PLANNING, ZONING, & BUILDING DEPARTMENT PZ&B Staff Memorandum: Town Council Development Review

SUBJECT: ZON-22-092 (ARC-22-137) 321 BARTON AVE (COMBO)

MEETING: August 10, 2022

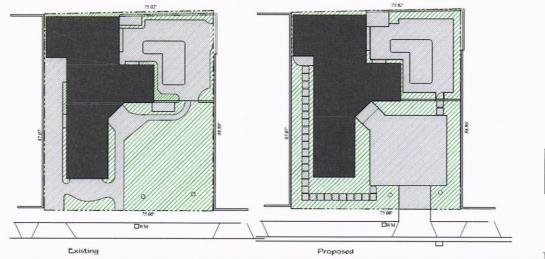
• Variance 1: Section 134-893(b)(12)a. - A variance for landscape open space of 30% in lieu

of the 35% existing and 45% minimum required.
